Service Bulletin

Bulletin No.: PI1156A

Subject: Outside Door Handle Does Not Open, Lock Rods Loose

Models: 2010-2014 Chevrolet Express
2010-2014 GMC Savana

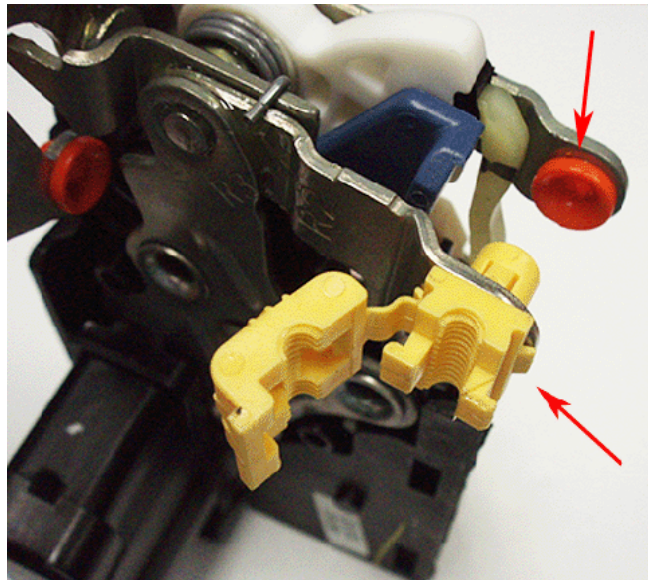
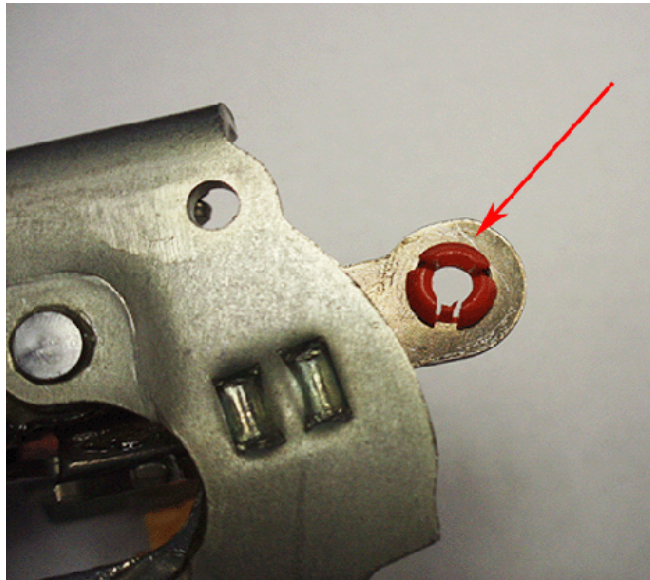
Some customers may comment that the outside door handle does not open the door. This may be caused by the lock rods becoming loose or disengaged from the clips in the front side door lock (latch).

Technicians should replace the two lock rod clips in the front side door lock (latch) with the parts listed below. Refer to Front Side Door Lock Replacement in SI. Refer to the lock rod clip pictures below. Remove the clips (red and yellow) with a suitable tool and replace.
